Change Order

PROJECT: *(Name and address)*
1208.3- Madison County Courthouse-
Cupola Repairs and Restoration
Canton, MS

CHANGE ORDER INFORMATION:
Change Order Number: 001

FIELD REPORT No FR3

BASIC FRAMING REPAIR PLAN

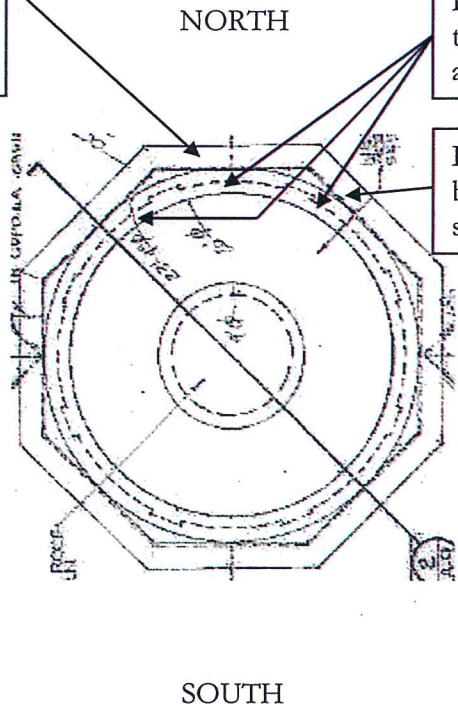
The three “curved beam” sections at the locations shown below will need to be replaced as the deterioration discovered was much worse than anticipated. We recommend using a doubled 16” wide LVL beam at each location. The collapsed 4x6 “outer beam” will need to be removed and replaced with a tripled 9-1/4” LVL beam. The beam can be cut to a narrower width if needed for assembly. The original 6x8 “outer beam” can be lifted back into place and secured to the column by adding the vertical 2x8 wood blocking attached to the side of the column and directly underneath the 6x8 for support. This same 2x8 blocking should also be installed under both ends of the tripled 9-1/4” LVL beam. The 2x8 vertical blocking was shown on the original contract drawings.

Replace 4x6 "outer beam" w/
triple 9-1/4" LVL. Install
support blocking under both
ends.

Damaged "curved beams" at
these 3 locations to be removed
and replaced.

Lift the left end of 6x8 "outer
beam" to original position. Install
support blocking underneath end.

Figure 5 – Deteriorated Sill Beam

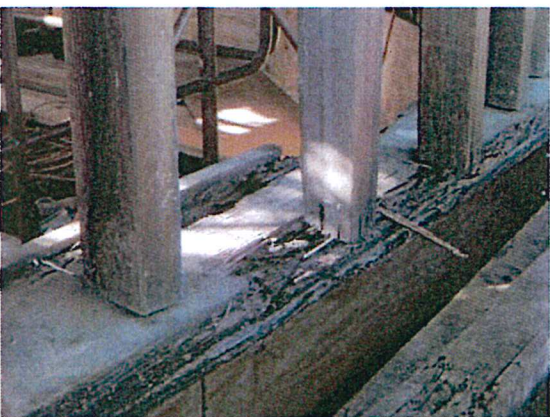
Figure 5: Upper section of support column at intersection of “outer beams” has deteriorated and split at original mortise joint. Figure 6: Upper beam at roof level has deterioration behind and above the blocking repairs that were made during a previous project.

Figure 13 – Base of Roof Flashing to be Sealed

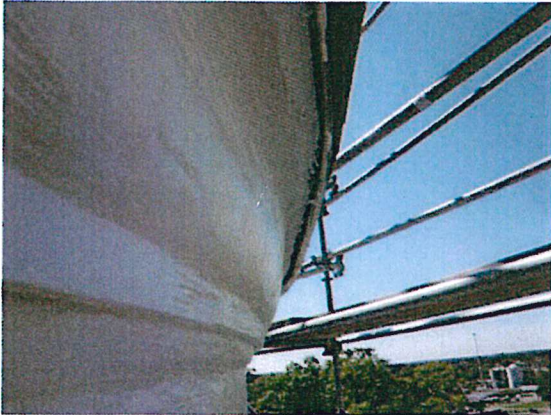
9. Gap under the Copper Dome Base Flashing at the roof edge will be filled with sealant. Any gap larger than ¼", backer rod will be installed. Any roofing felt hanging out will be cut back prior to sealant installation. **Figure 13**
